Wisconsin Department of Transportation

Proposal #14: 5990-01-34, WISC 2025080
C Janesville, W Court Street
Waveland Road to Pearl Street
Local Street
Rock County

This is Addendum No. 01, which provides for the following:

ADDENDUM NO. 01

Addendum No. 01
ID 5990-01-34
Revised Sheet 151
October 29, 2024

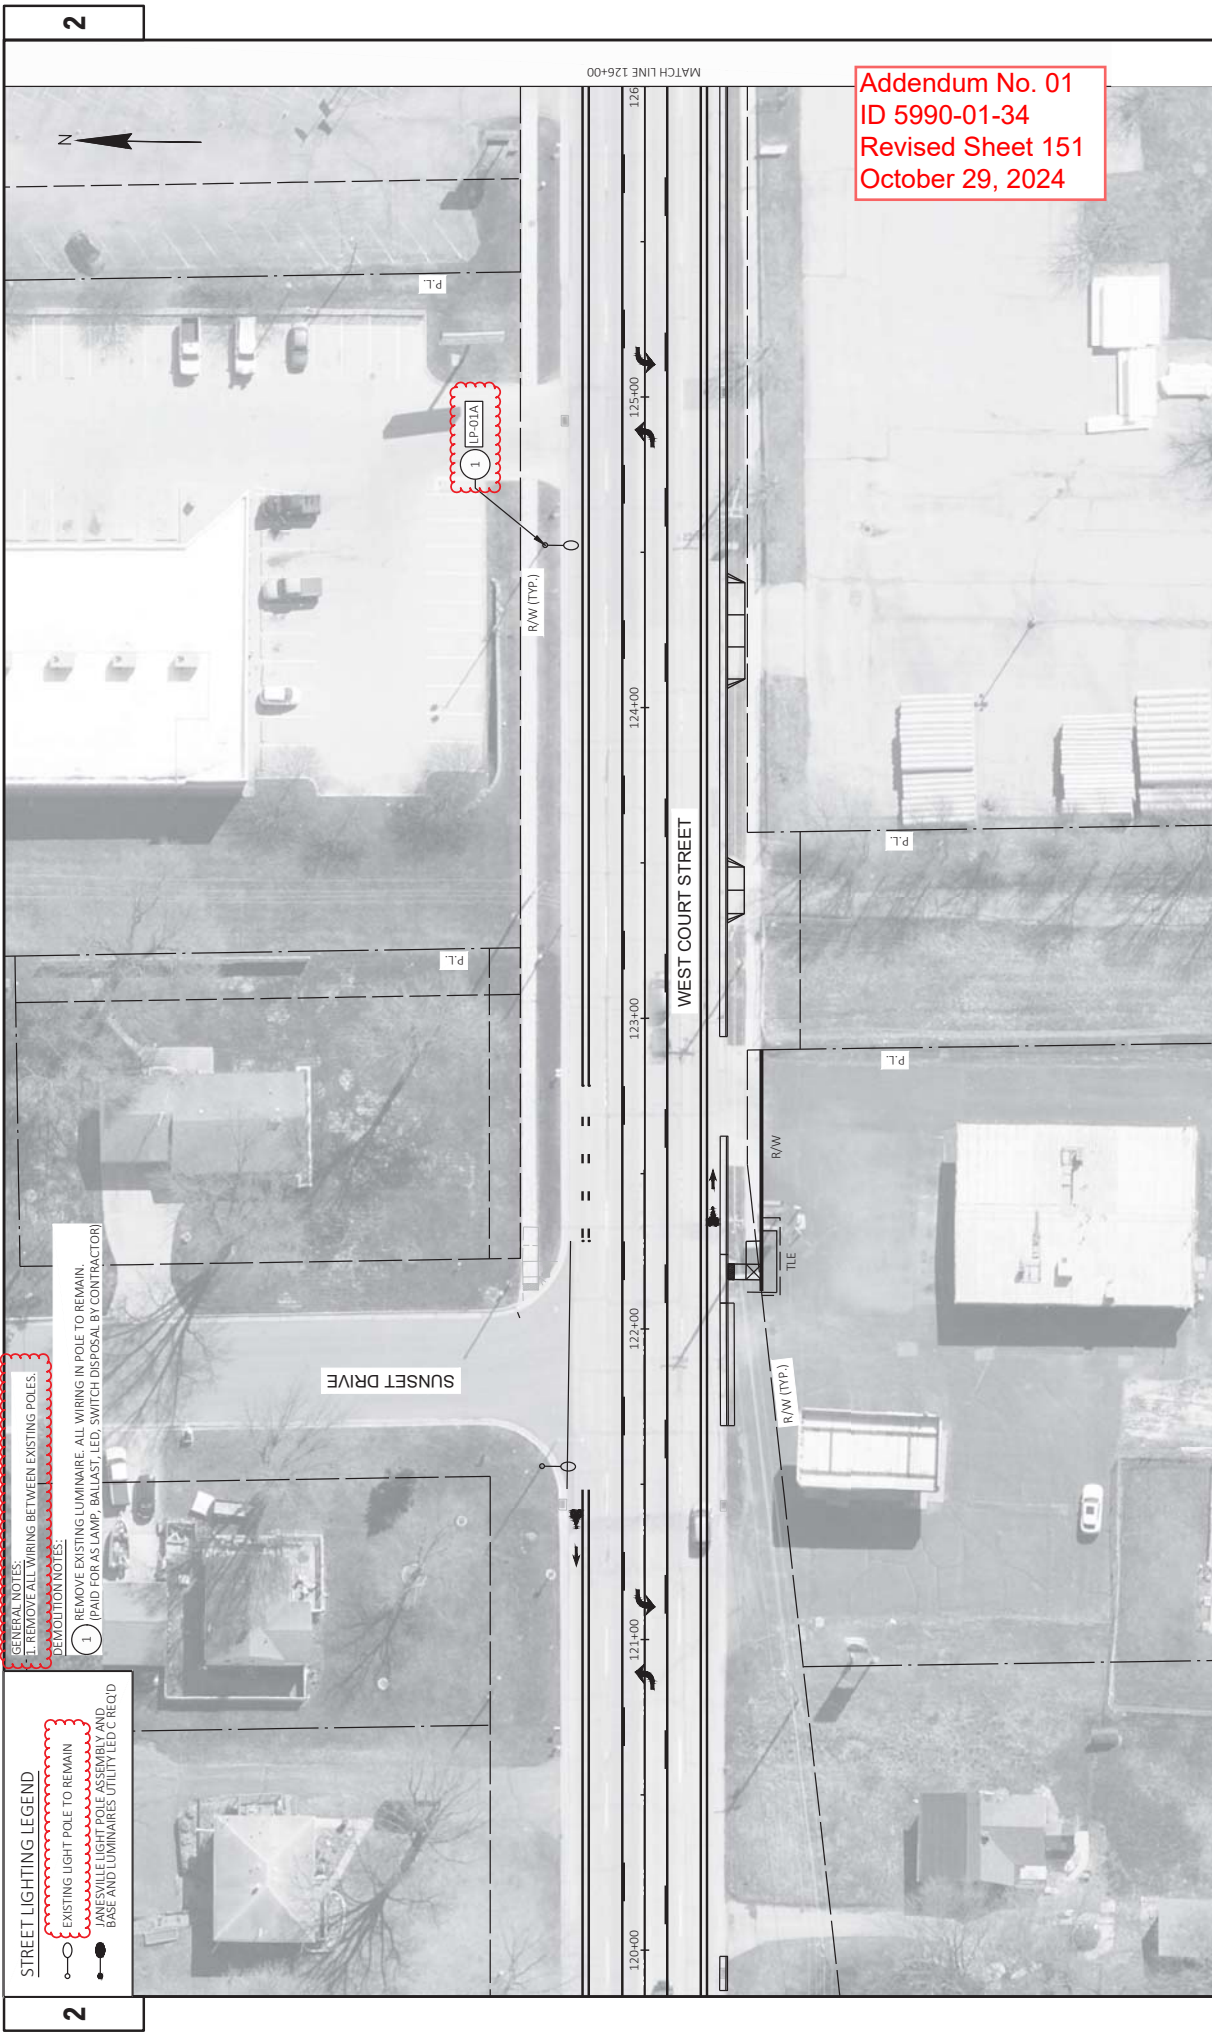
Revised Plan Sheets	
Plan Sheet	Plan Sheet Title (brief description of changes to sheet)
151-157	Lighting Removals (Revisions to legend, general notes, and lighting pole labels.)
158-164	Lighting Plan (Revisions to legend, general notes, and lighting pole labels.)
165	Lighting Plan - Wiring Diagram (Revisions to wire sizes.)
166	Lighting Plan (Revised callout and removed match line.)
247-248	Miscellaneous Quantities (Revisions to quantities.)
